PCN# 20230516003.1
Qualification of RFAB as an additional Fab site option for select HPA07 devices
Change Notification / Sample Request

Date: May 17, 2023
To: TOKYO ELECTRON DEVICE (DSTR) PCN

PCN Number:	20230516003.1	**PCN Date:**	May 17, 2023
Title:	Qualification of RFAB as an additional Fab site option for select HPA07 devices		
Customer Contact:	PCN Manager	**Dept:**	Quality Services
Proposed 1st Ship Date:	Aug 16, 2023	**Sample Requests accepted until:**	Jun 16, 2023*

Sample product shipping label (not actual product label)

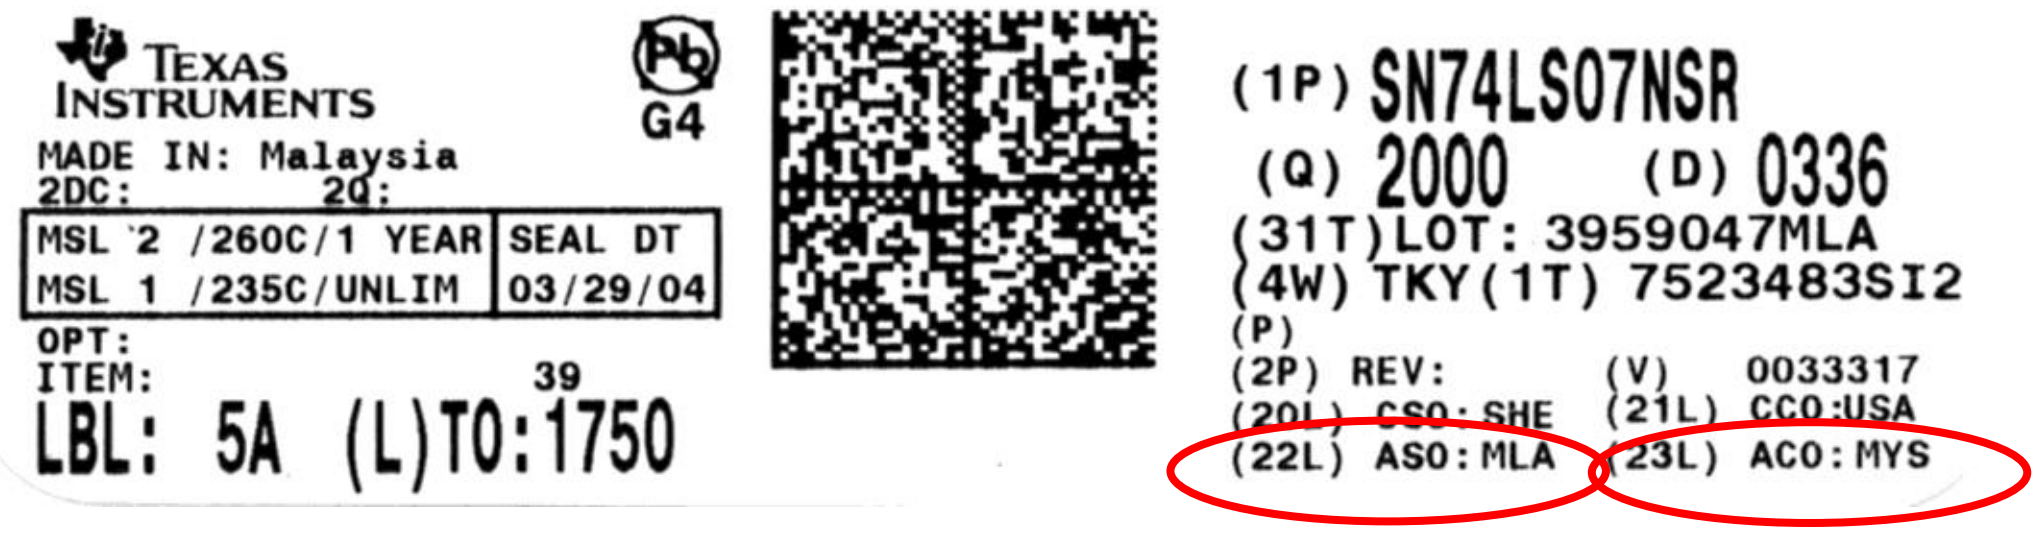
Changes to product identification resulting from this PCN:

Fab Site Information:

Chip Site	Chip Site Origin Code (20L)	Chip Site Country Code (21L)	Chip Site City
DP1DM5	DM5	USA	Dallas
RFAB	**RFB**	**USA**	**Richardson**
